## Product Change Notification

**1. ECR #:** 167953  
**Notification #:** 404

- IPBD - Power Cable Connector
- PMSD - .165 SOCKET DISCREET CABLE ASSEMBLY
- PMSDT - .165 SOCKET DISCREET CABLE ASSEMBLY

- IPBD-XX-D-X-X

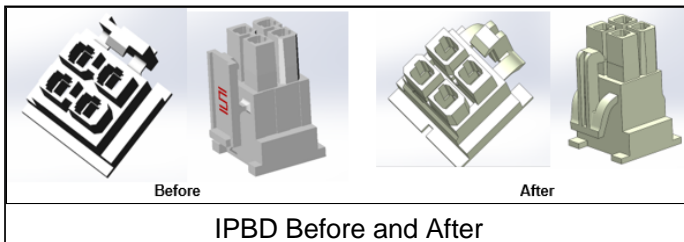
Samtec is revising the geometry and material for IPBD-D to improve latch functionality

These revisions improve the ductility & durability of the latch. The force/distance to latch & unlatch the mated pair will not change. The force required to overcome the latch will remain the same. The void coring between contact posts was increased to optimize manufacturability using the new material. Existing mates will connect/perform without compromise. Existing contacts will fit without concession. No influence on crimp and poke assembly. These changes are backwards compatible.

- Form - Latch geometry change
- Form - Increased void coring between towers
- Fit - These changes are compatible with existing mates, and crimp-contacts
- Function - These changes will not influence mechanical or electrical integrity of the connection
